STOCKTON UNIFIED SCHOOL DISTRICT

Expanded Learning Opportunities Program (ELOP) - Relocatable Classroom Buildings

The following additions, deletions and revisions to the plans, specifications and Addenda shall become a part of the plans and specifications. It is the responsibility of the General Contractor to submit the information contained in this addendum to all subcontractors and suppliers. The Bidder shall acknowledge receipt of the Addendum in the Bid Proposal. (Addendum number of pages: **32** pages + **77** attachments = **109** total pages).

JOB NUMBER:	23-12902
DWG. DATE:	02/20/25
	AD1-WIL-A201

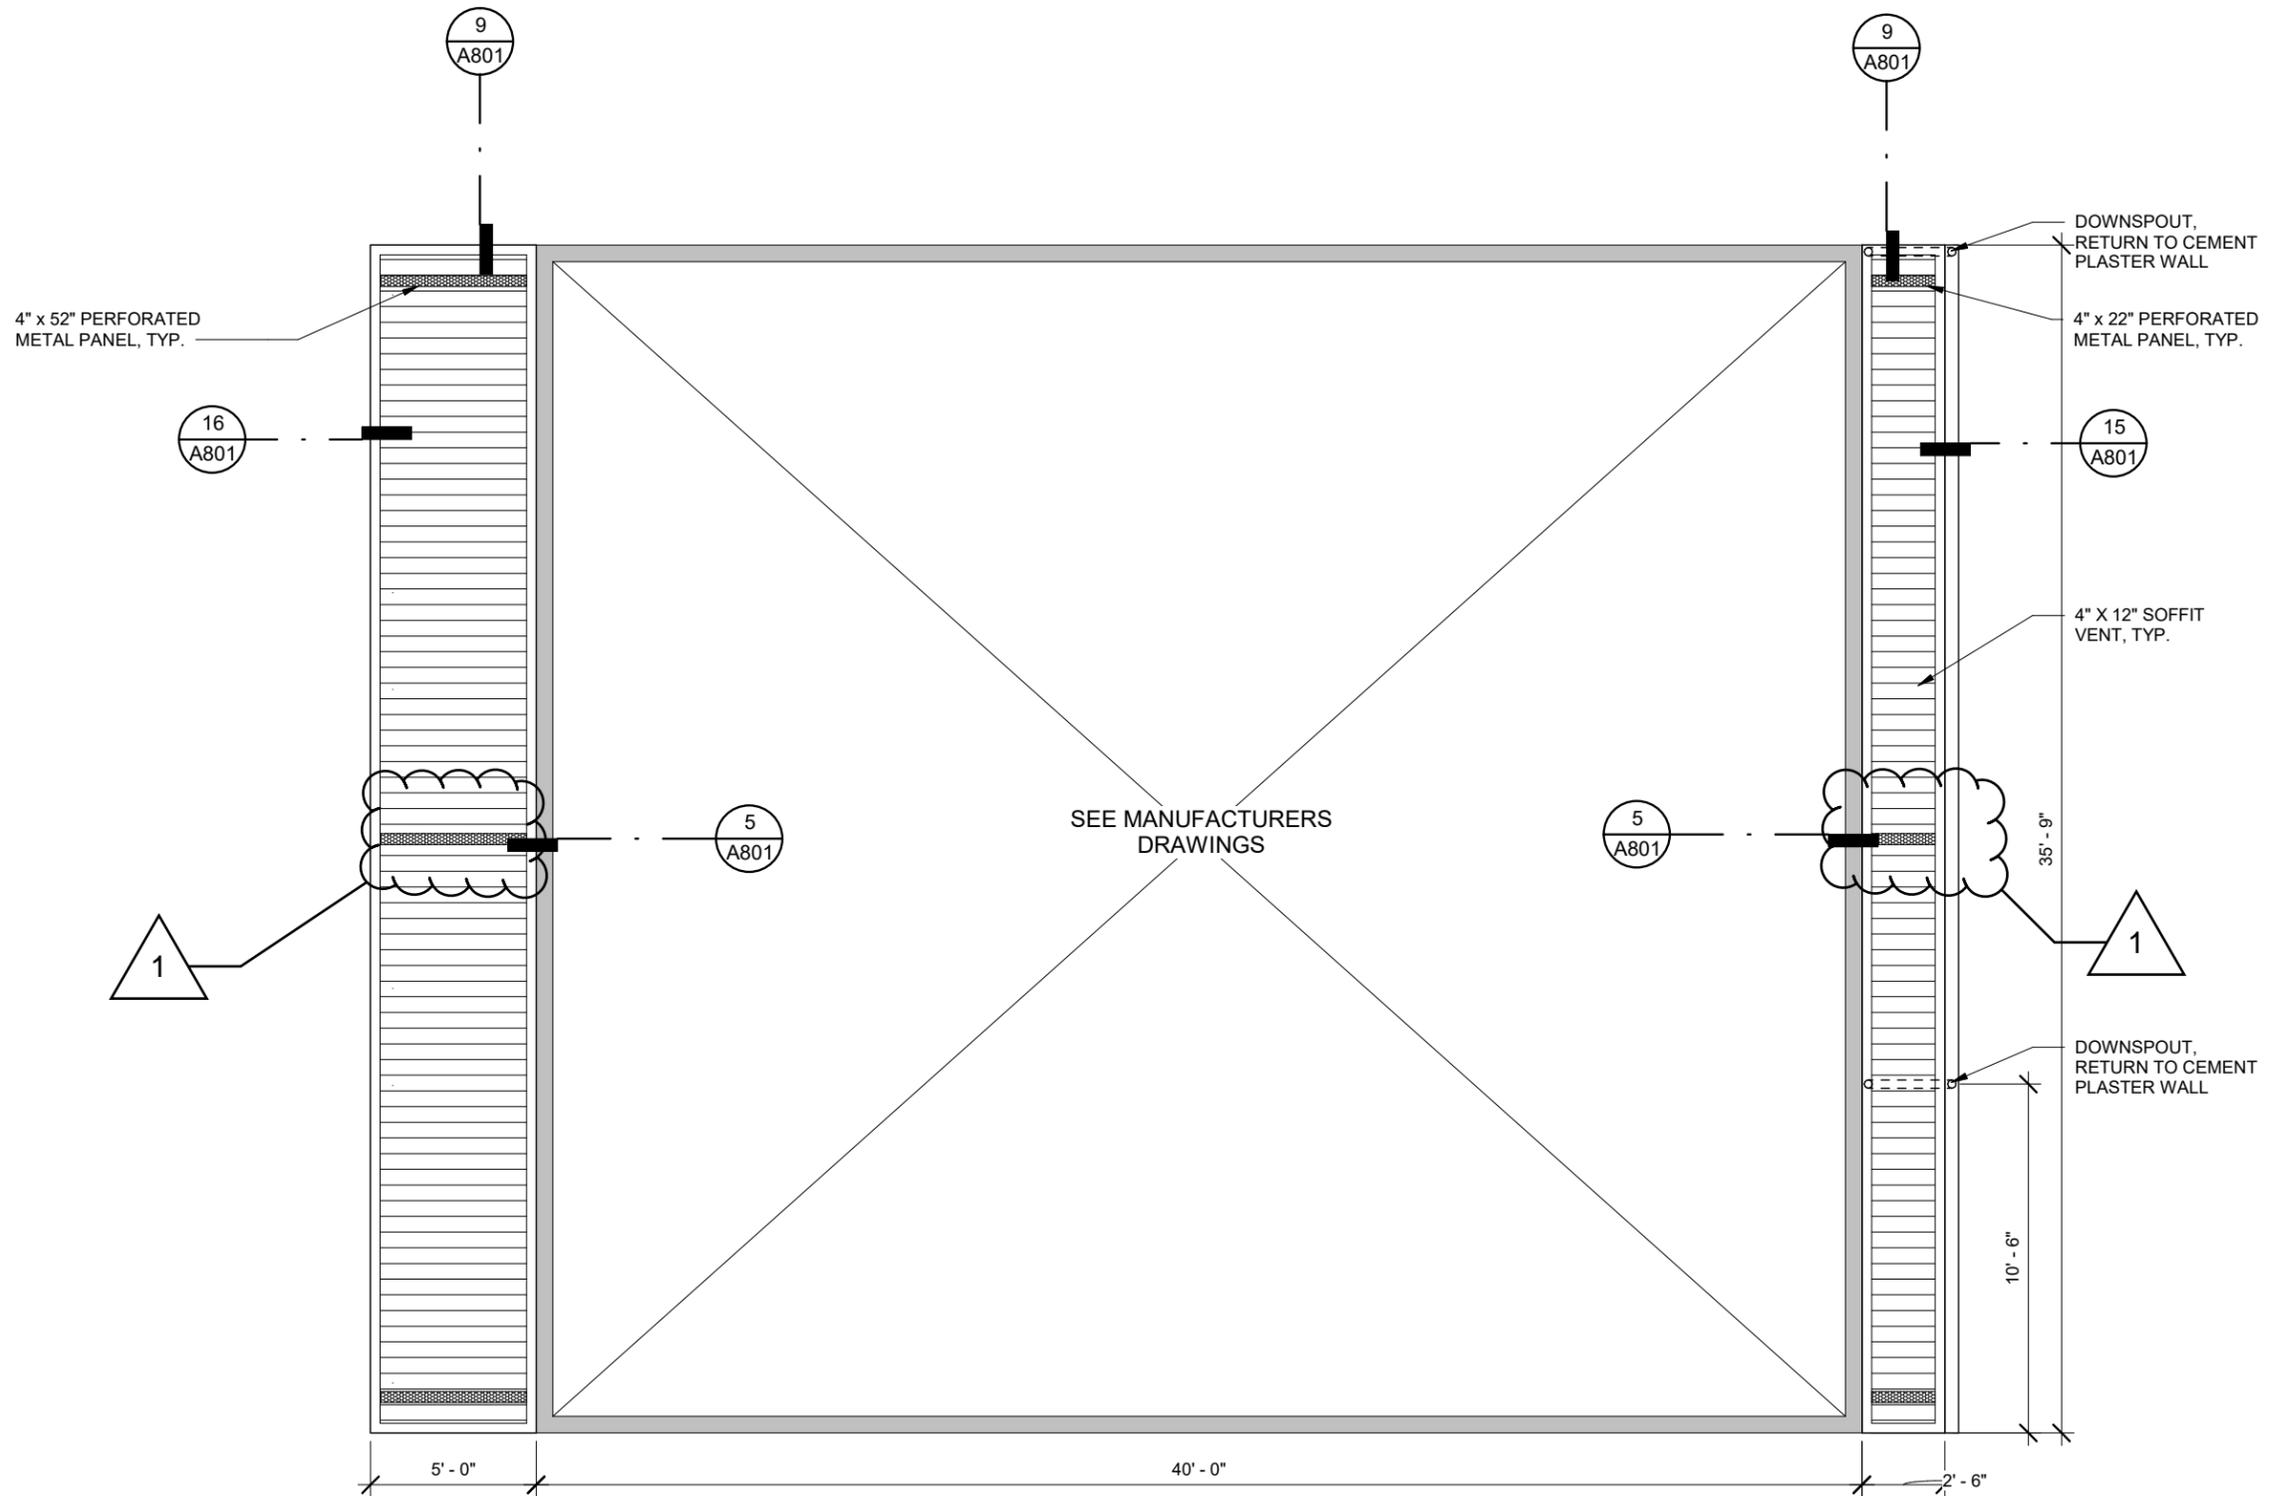
DRAWINGS:**1 - 046: DRAWINGS, SHEET A201 – “PLUMBING FLOOR PLAN”**, revise as follows:

A. Per attached drawing **AD1-WIL-A201**.

1. Detail 1 has been revised.

JOB NUMBER:
23-12902
 DWG. DATE:
02/20/25
 AD1-WIL-
 A801

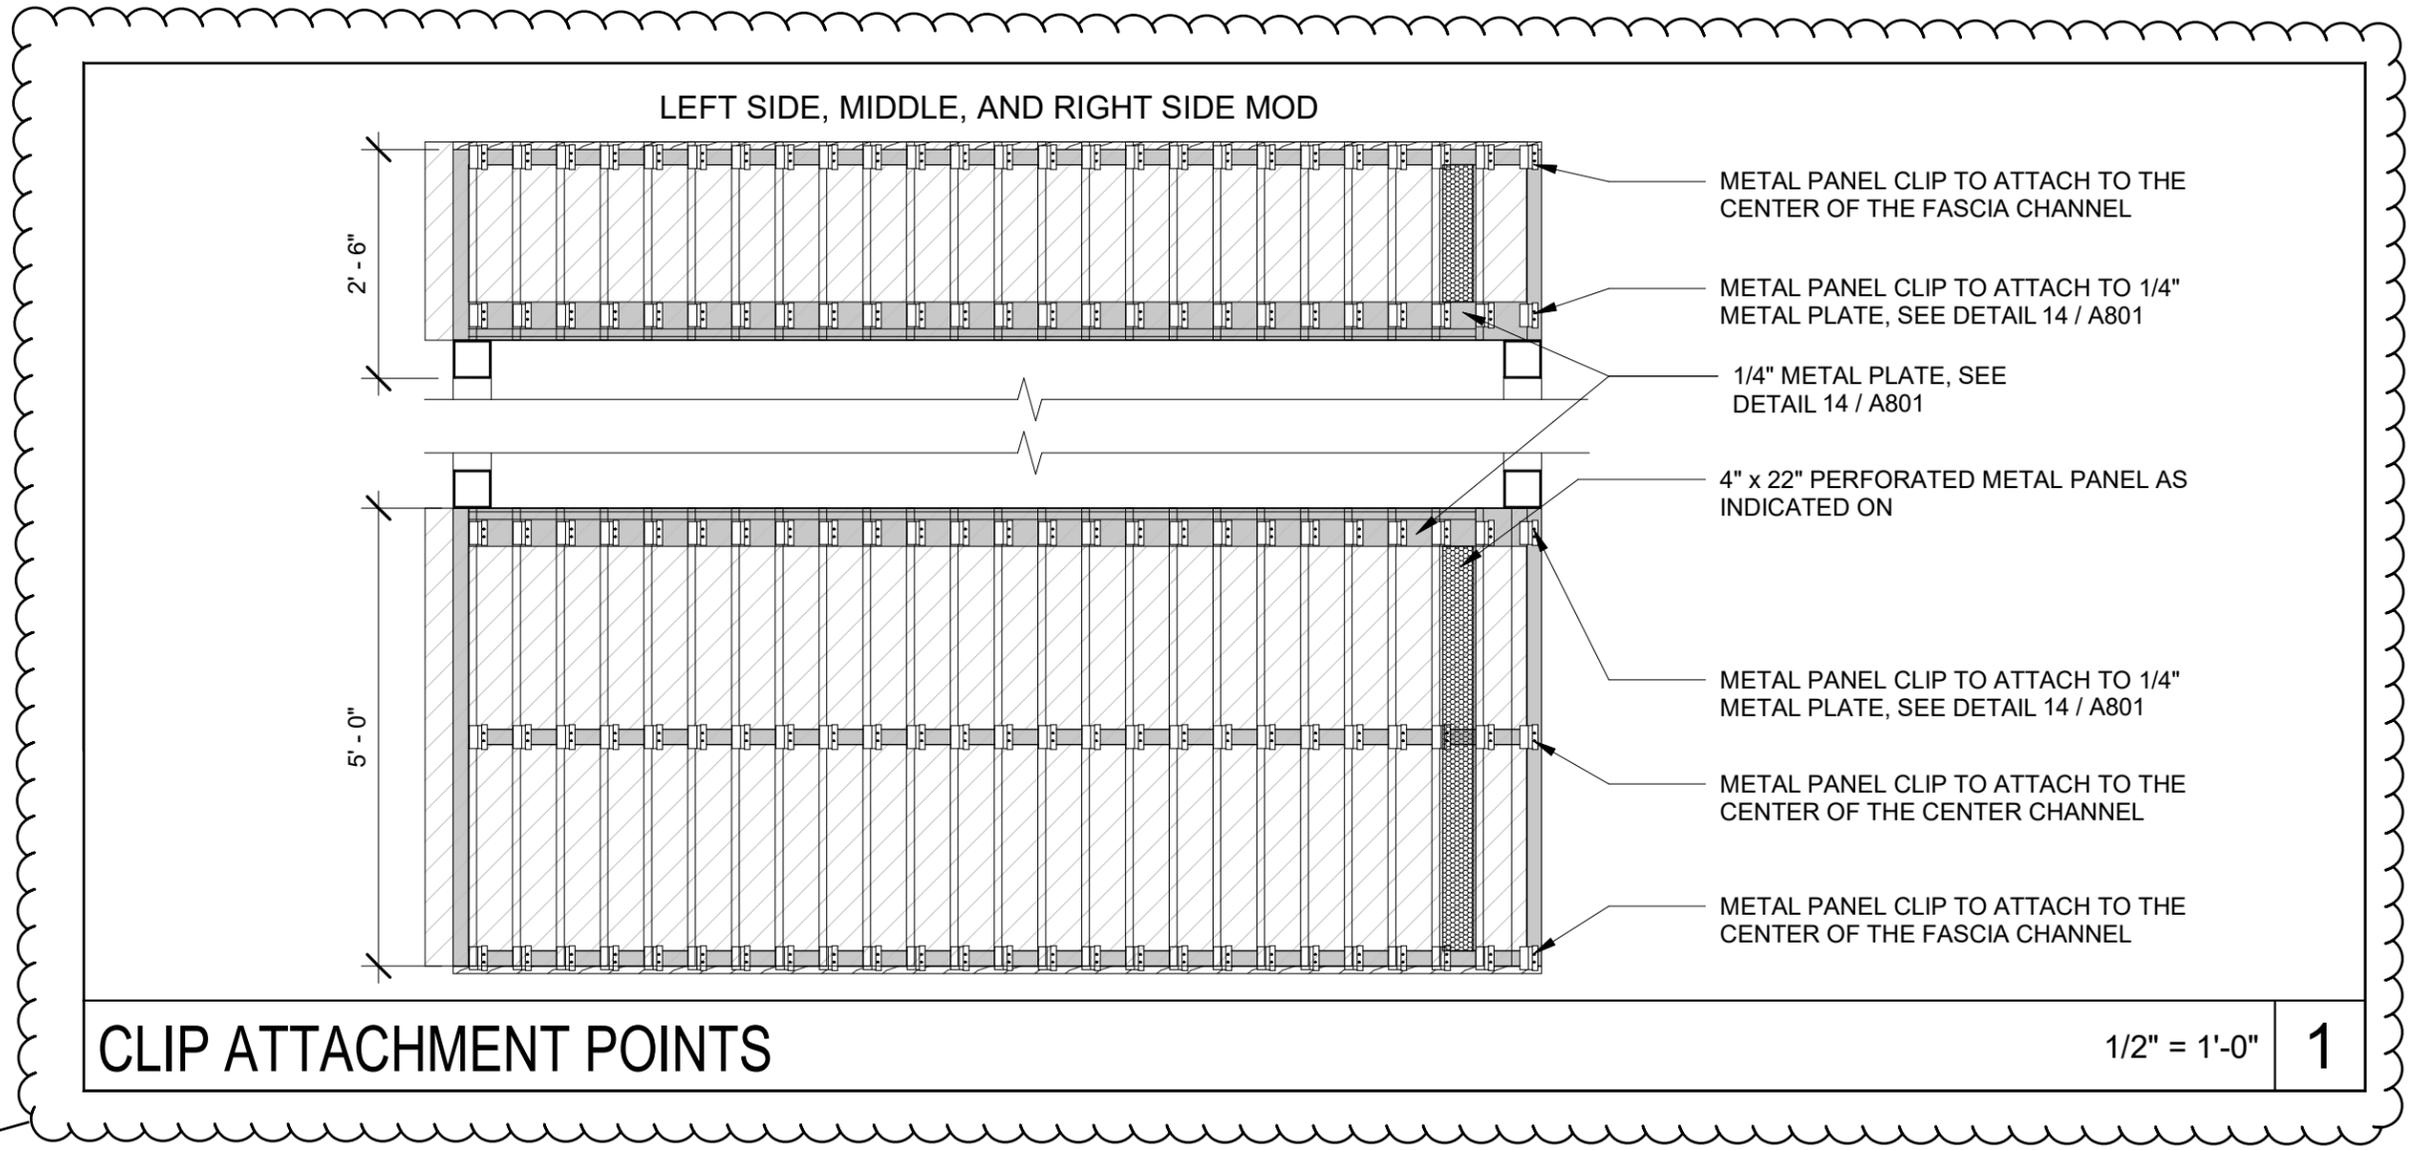
1 - 048: DRAWINGS, SHEET A801 - “EXTERIOR DETAILS”, revise as follows:

A. Detail 14 – Clip fastener note revise to “(2) #12 SMS w/3 THRED INTO STRUCTURE PER CLIP”

B. Per attached drawing **AD1-WIL-A801**

1. Detail 15 and 16 - Additional fastener information has been provided.

AD1-ROO-
A102

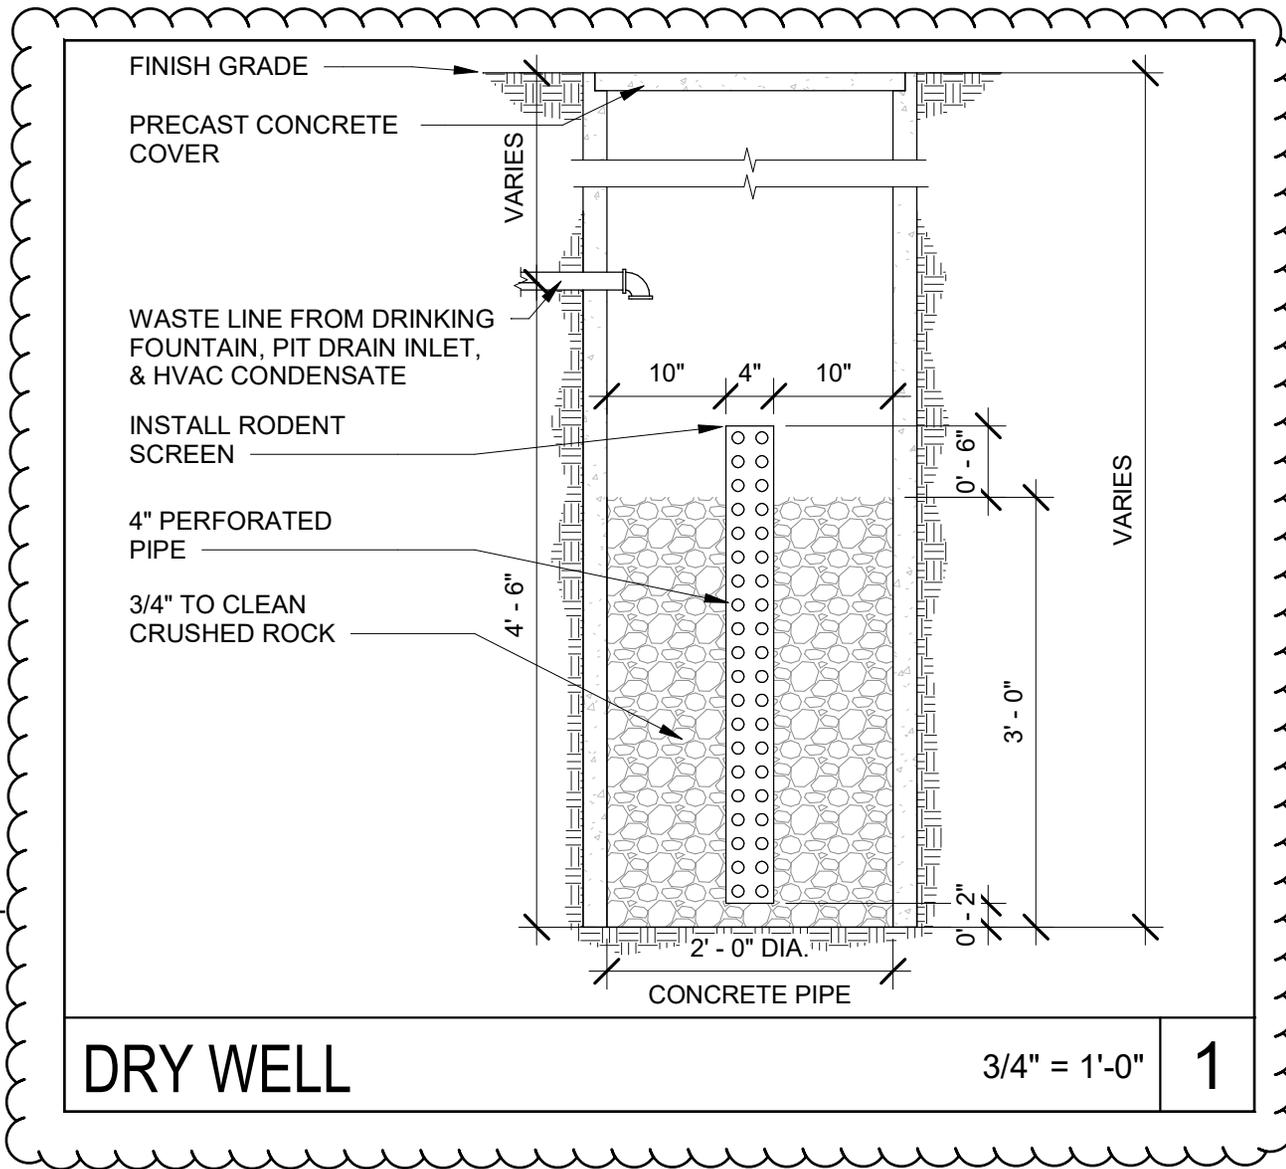
1 - 058: DRAWINGS, SHEET A102 – “PROPOSED ENLARGED SITE PLAN”, revise as follows:

A. Per attached drawing **AD1-ROO-A102**.

1. Concrete mow strip added at new light pole.

AD1-ROO-
A201

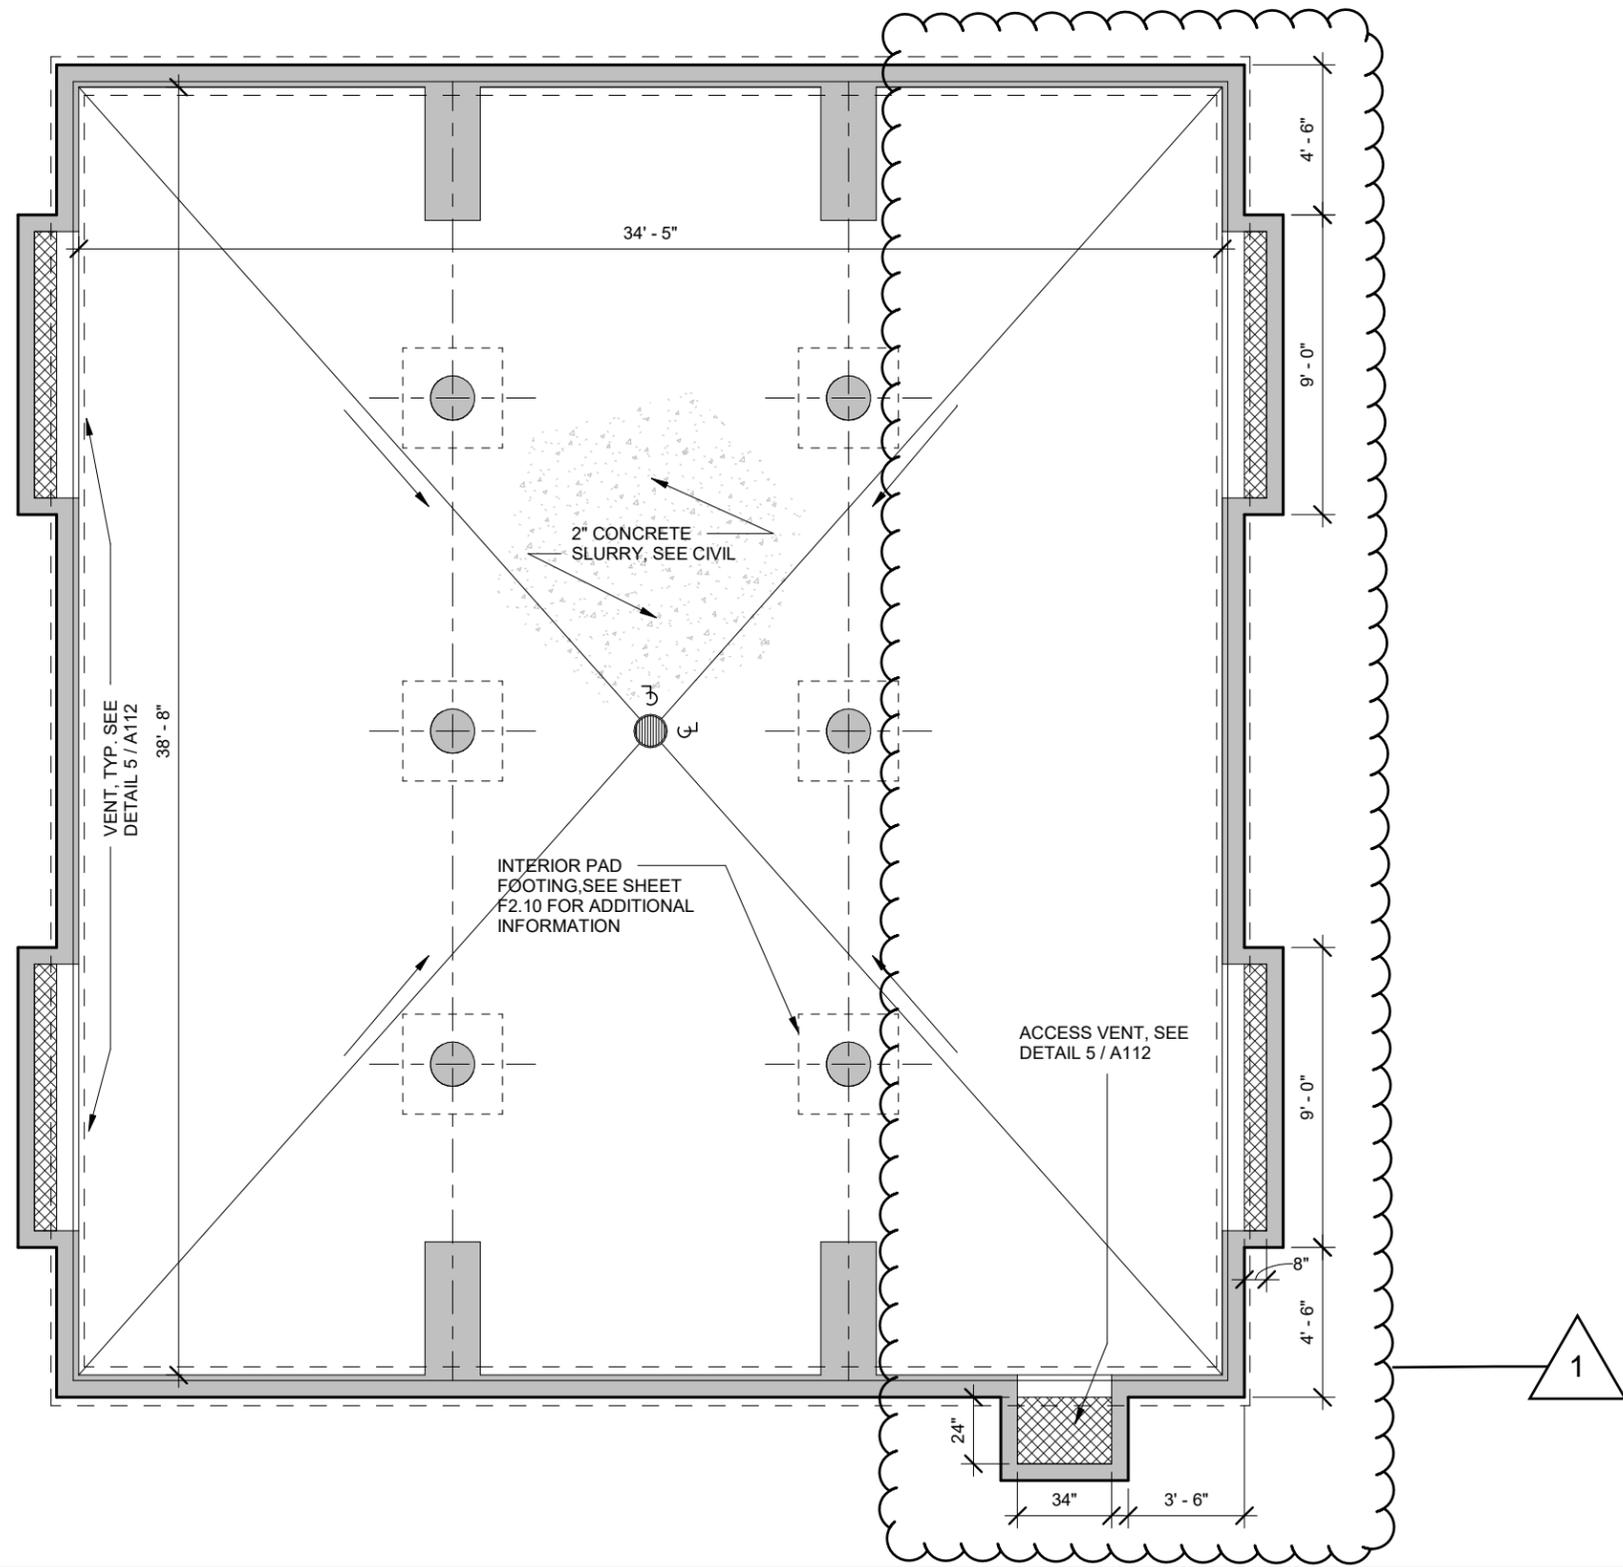
1 - 059: DRAWINGS, SHEET A201 – “PLUMBING FLOOR PLAN”, revise as follows:

A. Per attached drawing **AD1-ROO-A201**.

1. Detail 1 has been revised.
